Common Structural Rules for Bulk Carriers and Oil Tankers

Draft Rule Change Proposal 1 to 01 JAN 2021 version

RULE CHANGE PROPOSAL 1

Figure 3: Net sectional properties of local supporting members (continued)

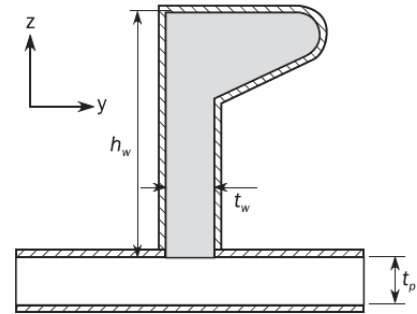
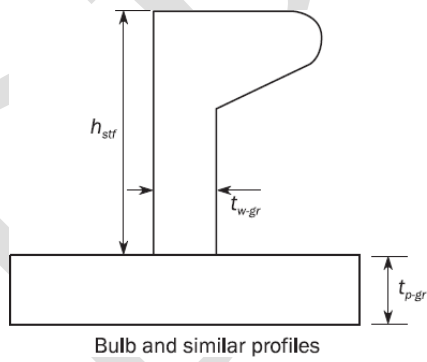
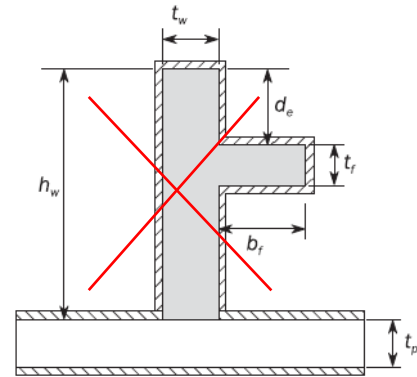
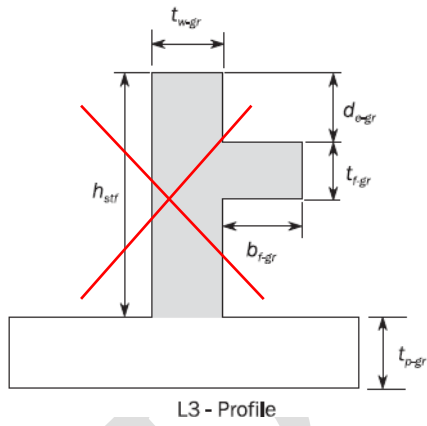
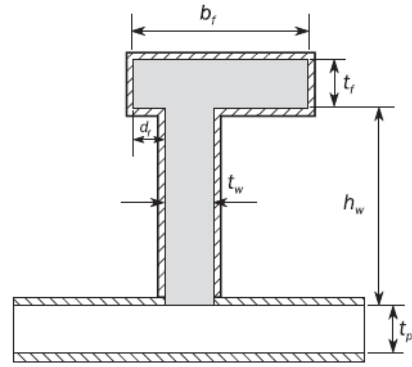
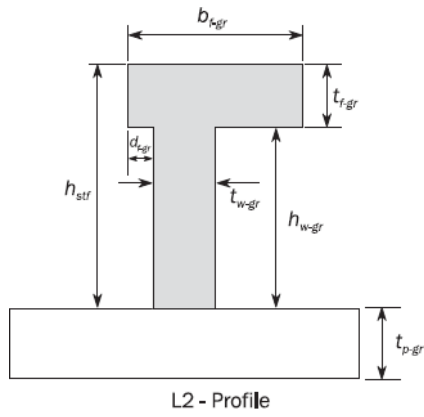
~~d_e : Distance in mm, from the upper edge of the web to the top of the flange for L3 profiles, see Figure 3.~~

- For T, L (rolled and built-up) profiles and flat bar, as defined in Ch 3, Sec 2, Figure 2.
- For L2 ~~and L3~~ profiles as defined in Ch 3, Sec 2, Figure 3.
- For bulb profiles, to be taken as defined in [1.4.1].

- $h_{f-ctr} = h_w + 0.5 t_f$ for profiles with flange of rectangular shape ~~except for L3 profiles~~ and for bulb profiles.
- ~~$h_{f-ctr} = h_w - d_e - 0.5 t_f$ for L3 profiles as defined in Ch 3, Sec 2, Figure 3.~~

~~d_e : Distance from upper edge of web to the top of the flange, in mm, for L3 profiles, see Ch 3, Sec 2, Figure 3.~~

Table 1: Slenderness coefficients

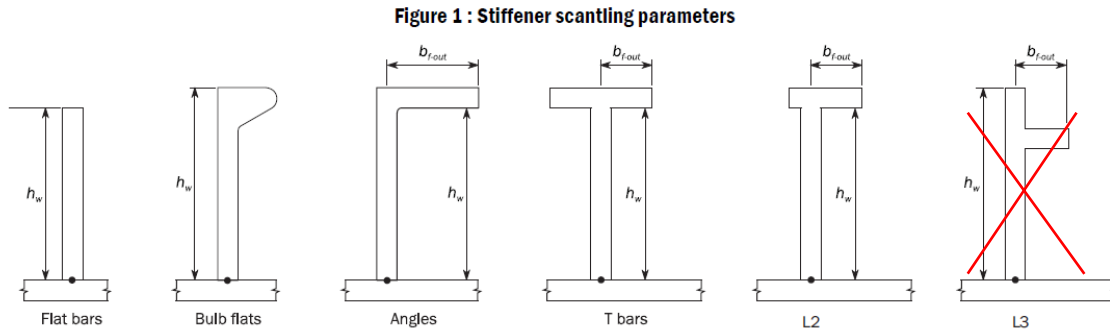
Type of Stiffener	C_w	C_f
Angle <u>and</u> L2 <u>and</u> L3 bars	75	12
T-bars	75	12
Bulb bars	45	-
Flat bars	22	-

Figure 1: Example of hatch cover fitted with U-type stiffener

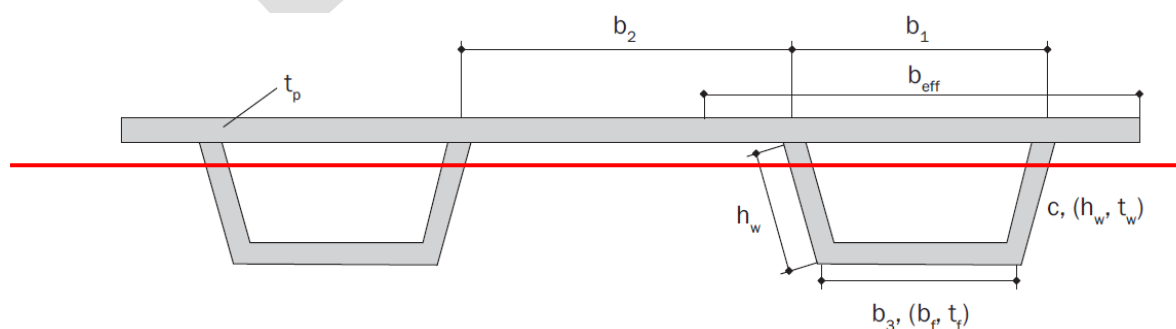
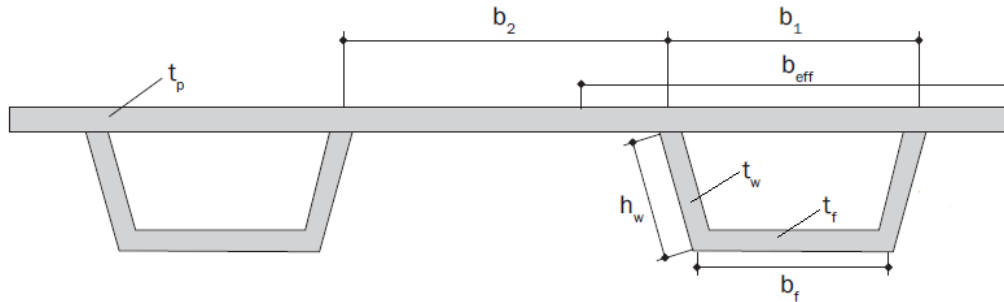
~~It is also applicable for hatch covers fitted with U-type stiffeners as shown in Figure 1. In the latter case, i.e. when the hatch cover is arranged as a grillage of longitudinal and transverse primary supporting members, or when the Society deems it necessary, t~~he stresses in the primary supporting ~~all structural~~ members are to be determined by ~~a grillage or~~ a finite element analysis with the modelling requirements as described in [5.6.1].

The hatch covers fitted with U-type stiffeners as shown in Figure 1 are to be checked by means of FE analysis. ~~In transverse section of the stiffener, nodes are to be located at the connection between the web of the U-type stiffener and the hatch cover plate as well as at the connection between the web and the flange of the U-type stiffener. The buckling assessment as described in [5.2.3], [5.3.4] and [5.4.6] can be made considering only the stresses given by the FE analysis.~~

For hatch covers fitted with U-type stiffeners, it is to comply with the requirements in [5.6.4]. the buckling panels b_1 , b_2 , b_3 and c (see Figure 1) are to be assessed separately

The buckling strength of the hatch cover fitted with U-type stiffeners subjected to loading conditions as defined in [4.1] ~~is to comply with the requirements in [5.6.4]. is to be checked as detailed above,~~ considering the U-type as an equivalent T-bar profile as follows:

- Flange breadth taken as b_3 , as shown on Figure 1.
- Flange thickness taken as t_f , as shown on Figure 1.
- Effective width of the attached plating, b_{eff} , taken as:

Hatch covers fitted with U-type stiffeners as shown in Figure 1 are to be assessed by means of FE analysis. The geometry of the U-type stiffeners is to be accurately modelled using shell/plate elements. Nodal points are to be properly placed on the intersections between the webs of a U-type stiffener and the hatch cover plate, and between the webs and flange of the U-type stiffener.

For hatch covers fitted with U-type stiffeners, local plate buckling is to be checked for each of the plate panels EPP b_1 , b_2 , b_f and h_w (see Figure 1) separately as follows:

Figure 3 : Hatch cover top/bottom plating structures

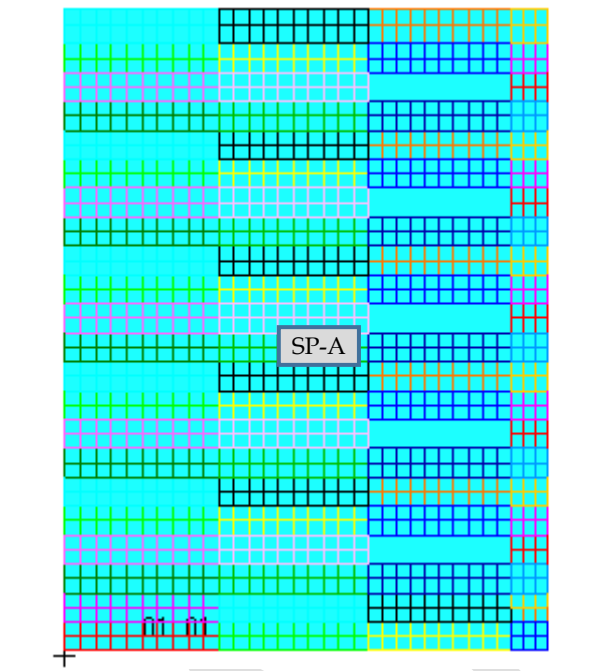
The plate panel of a hatch cover structure is to be modelled as stiffened panel (SP) or unstiffened panel (UP). Assessment Method A (-A) and Method B (-B) as defined in Pt 1, Ch 8, Sec 1, [3] are to be used in accordance with Table 4, Figure 3 and Figure 4. For a web panel with opening, the procedure for opening should be used for its buckling assessment.

<u>Structural elements</u>	<u>Assessment method^[1,2]</u>	<u>Normal panel definition</u>
<u>Hatch cover top/bottom plating structures, see Figure 3</u>		
<u>Hatch cover top/bottom plating</u>	<u>SP-A</u>	<u>Length: between web frames</u> <u>Width: between primary supporting members</u>
<u>Irregularly stiffened panels</u>	<u>UP-B</u>	<u>Plate between local stiffeners/PSM</u>
<u>Hatch cover webs of primary supporting members, see Figure 4</u>		
<u>Web of transverse/longitudinal girder (single skin type)</u>	<u>UP-B</u>	<u>Plate between local stiffeners/face plate/PSM</u>
<u>Web of transverse/longitudinal girder (double skin type)</u>	<u>SP-B^[3]</u>	<u>Length: between web frames</u> <u>Width: full web depth</u>
<u>Web panel with opening</u>	<u>Procedure for opening</u>	<u>Plate between local stiffeners/face plate/PSM</u>
<u>Irregularly stiffened panels</u>	<u>UP-B</u>	<u>Plate between local stiffeners/face</u>
